# OMOCHUMNE-HARTNELL WATER DISTRICT: GROUNDWATER RECHARGE PROJECT

Addendum to the Mitigated Negative Declaration  
State Clearinghouse # 2018072026

Prepared for  
Omochumne-Hartnell Water District

May 2026

**Figure 1**  
Original and Addendum Project Components

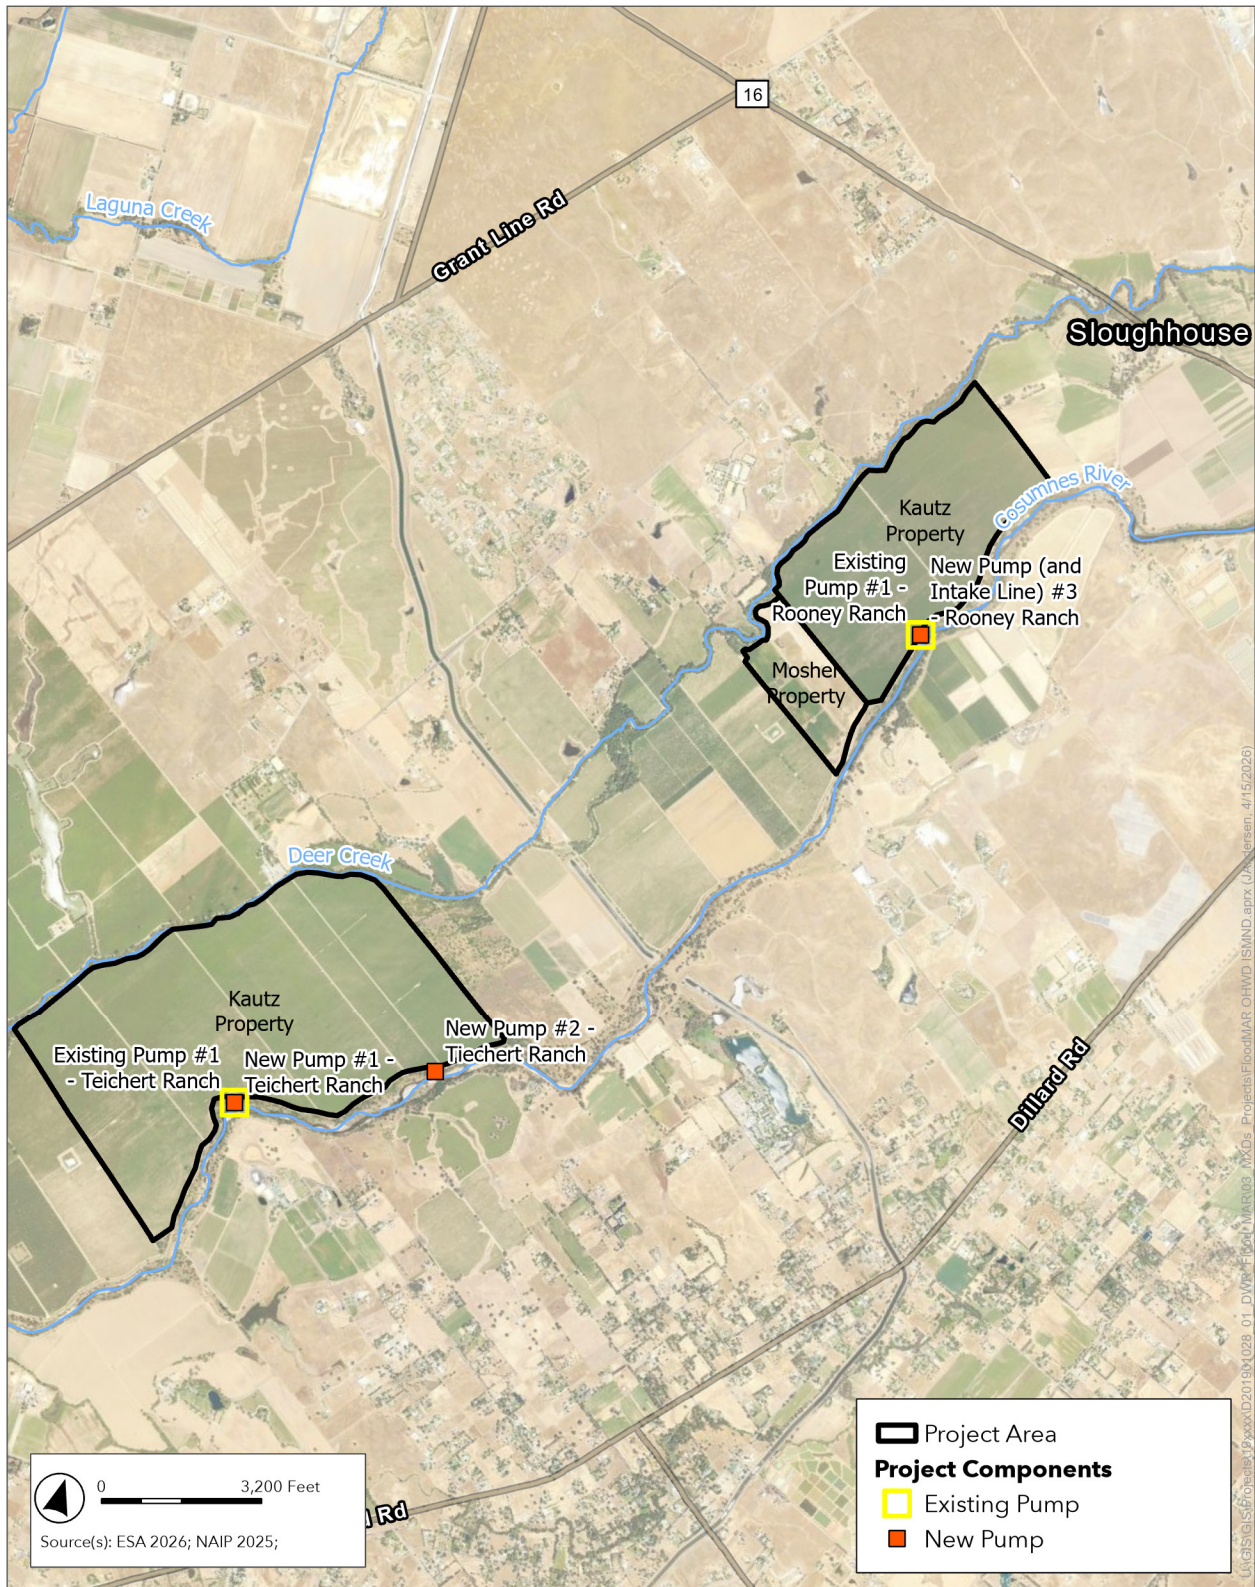
The District is proposing several changes as shown in **Figure 1**. The revised Project would result in the upgrading of the existing pump and the addition of a new pump at Field Site 1 – Teichert Ranch (Kautz Property 1). Another new pump would be constructed at Teichert Ranch, approximately 4,300 feet upstream of Field Site 1. A new pump would also be added at Field Site 2 – Rooney Ranch (Kautz Property 2).

The existing pump station at Teichert Ranch would be upgraded by adding a C78-21TA cone fish screen. The screen unit consists of a conical-shaped wedgewire screen, an external brush cleaning system, and brush drive assembly with controls. The mechanical brushing action prevents debris buildup, sedimentation, biofouling, and increased head loss at the screen.

A new pump would be added to the existing pump station at Teichert Ranch. The second pump at this location would allow a maximum diversion capacity of 4,000 gallons per minute (gpm). Currently, the existing pump cannot reach its flow rate due to pump design. The pump would be placed on a smoothed-out earthen 10x25-foot area. A connection would be made to the existing conveyance pipeline.

A second new pump would be located at Teichert Ranch, approximately 4,300 feet upstream of the existing pump station. This pump would be the same as the pump to be installed at the existing Teichert Ranch site. The pump would be placed on a smoothed-out earthen 10x25-foot area and have a 4,000 gpm capacity. A new intake line would be installed through the levee and a connection would be made to the existing conveyance pipeline.

A third new pump would be added to the Rooney Ranch site at the existing pump station. This pump would be similar to the other new pumps and would also require a new intake line through the levee and connection to the existing conveyance pipeline. The capacity of this pump would be approximately 4,000 gpm.

In total, capacity at Teichert Ranch would increase from 5,000 gpm to approximately 13,000 gpm. Capacity at Rooney would increase from 3,465 gpm to approximately 7,500 gpm. In total, the diversion capacity would increase from approximately 8,345 to 20,500 gpm.
